**Project Name: \*** B-5639 Duplin County

**B-5639**, Replace Bridge 36 on NC 11 over Maxwell Creek, Duplin County

**WETLAND AND SURFACE WATER IMPACTS PERMIT**

The application has been received and reviewed and found to be incomplete for processing. I have discussed the project with DWR and we request the following information to continue processing:

**PERMIT DRAWING  
SHEET 4 OF 17**

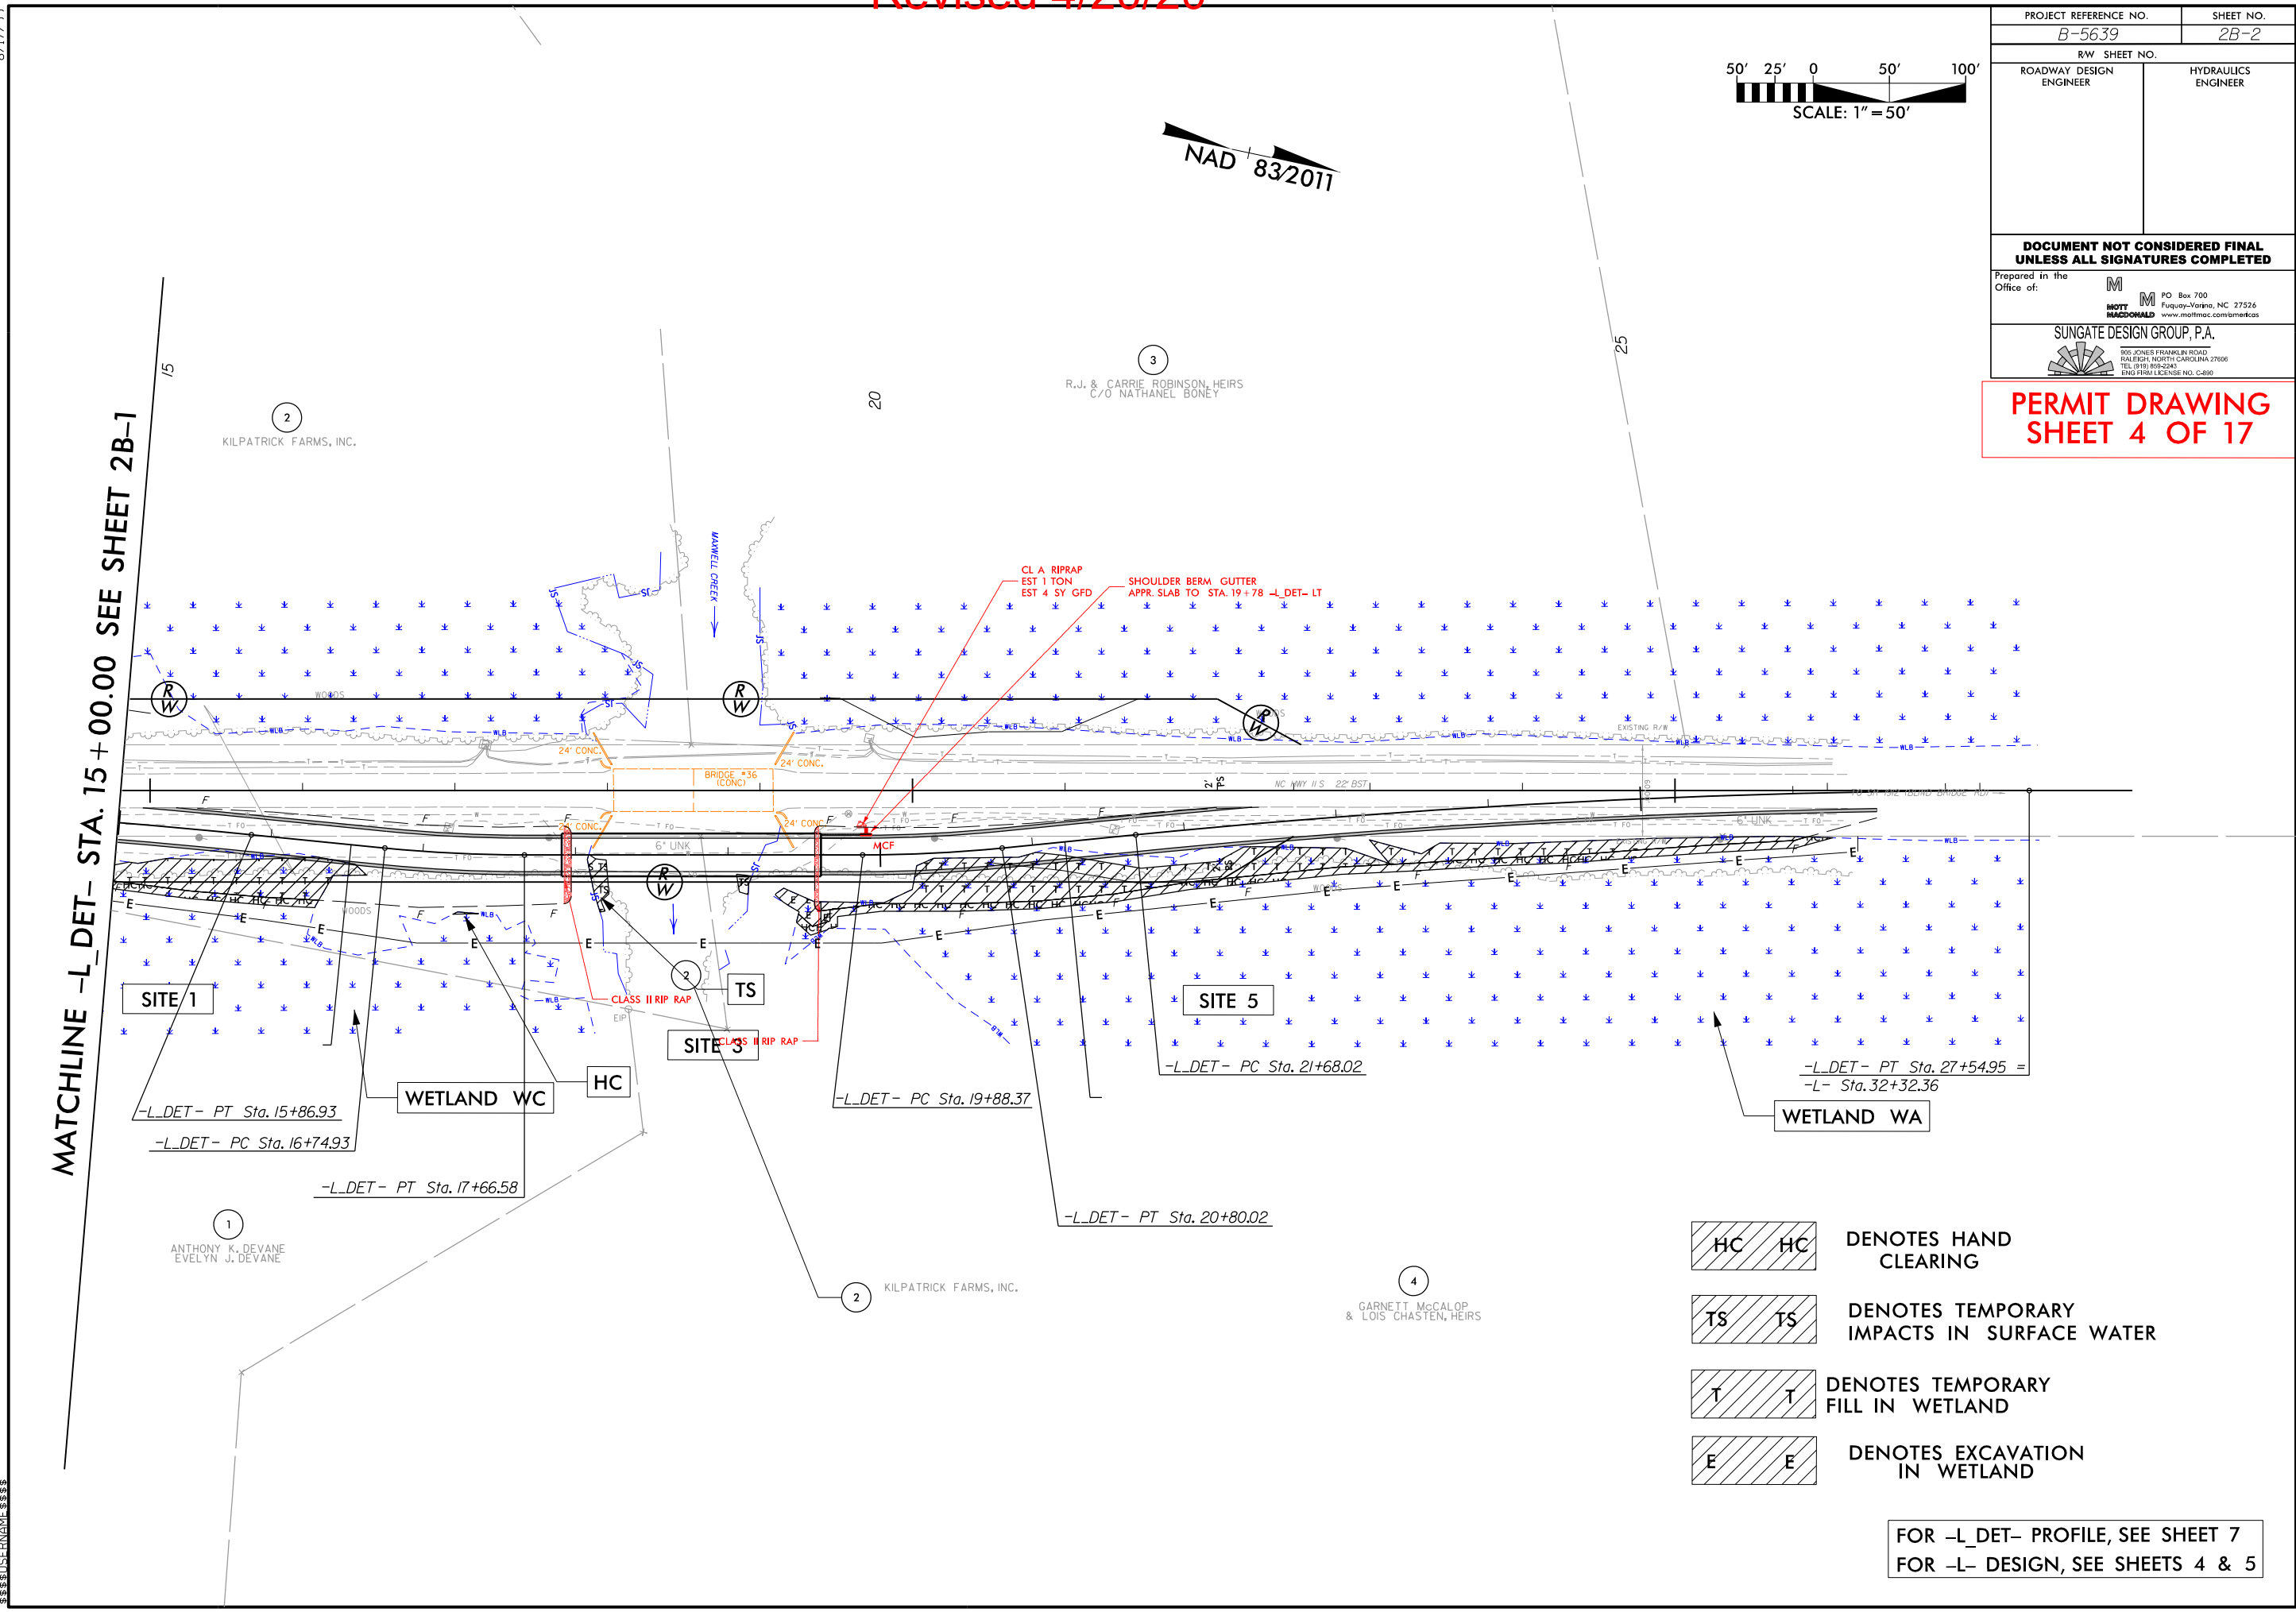
- Please include the mitigation reservation letter from NC DMS.
- The current plan calls for permanent impacts (MC) bordering the temporary impacts. Typically temporary impacts are bordered by temporary impacts (HC). Please either change this or explain why additional avoidance can't be realized.

3. The drawings have been changed to put handclearing outside of the detour instead of mechanized.
4. Sheet 5 is in the new package. (attached)
5. Division 2 has indicated that the slope of the temporary detour will be wrapped with geotextile fabric to aid in restoring the area back to preexisting elevations. A reforestation detail sheet has been prepared by our mitigation and monitoring group (attached), and the site can be monitored for 2 years if desired.

## WETLAND REFORESTATION DETAIL SHEET

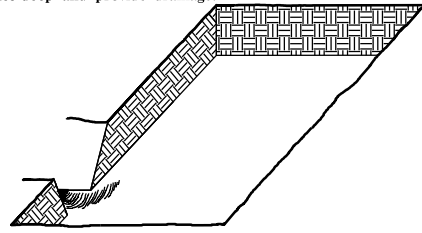
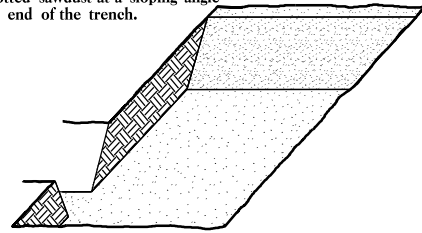
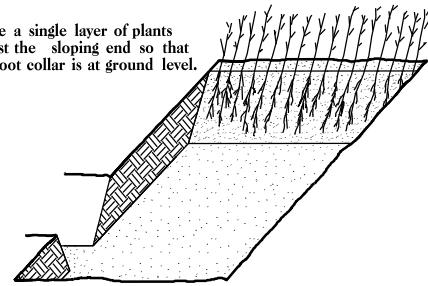
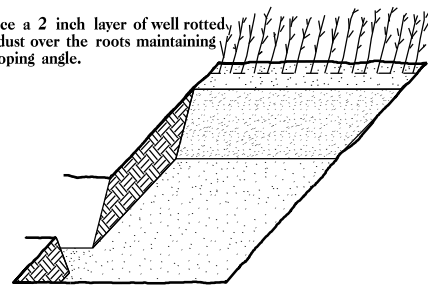
- Finally, the temporary fill in wetlands is greater than 0.25 of an acre. Please further explain how this temporary impact will be constructed and what steps will take place to avoid permanent impacts such as compaction. Also further explain the restoration activities anticipated upon project completion to include how will successful restoration be judged. With this amount of impact will at minimum a couple years of monitoring be appropriate?
